SPECIFICATION AMENDMENT

2/6

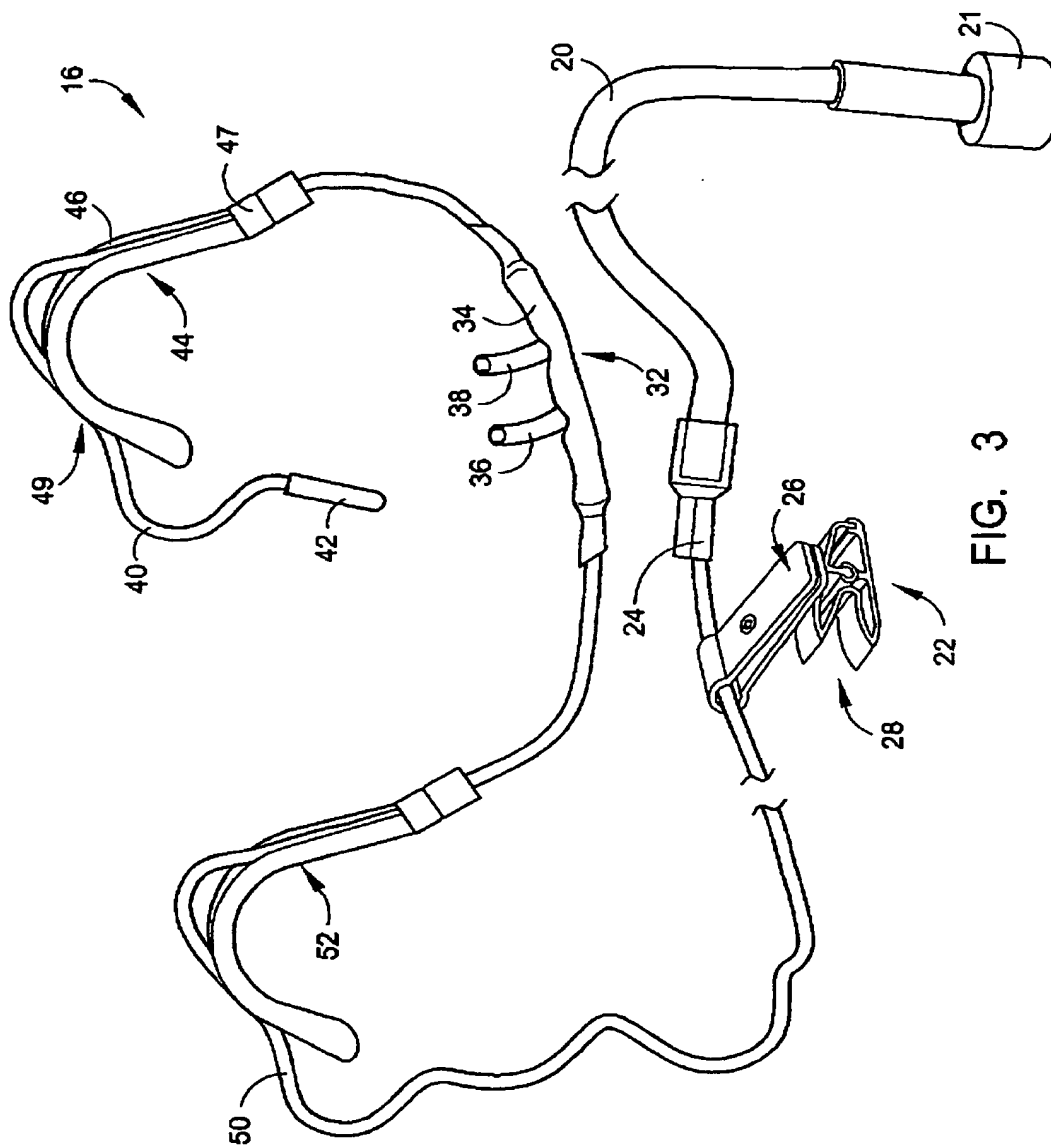
The examiner objected to the drawings under 37 CFR. 1.83(a) as not showing every feature of the invention specified in the claims. In order to render the drawings consistent with the claims, which form part of the specification as originally filed, FIG. 2 of the drawings has been amended to show the securing arrangement 22 attached to the extension tube 50 as opposed to tube 20. In this regard, in the claims as originally filed claim 11 recited that the "securing clip" was "mounted to said section of fluid delivery tubing". The proposed amendment to FIG. 2 therefore does not constitute new matter and is made only to make the drawing consistent with the specification as originally filed.

A replacement for Sheet 2/6 is enclosed with this amendment and is so identified as a "Replacement Sheet".
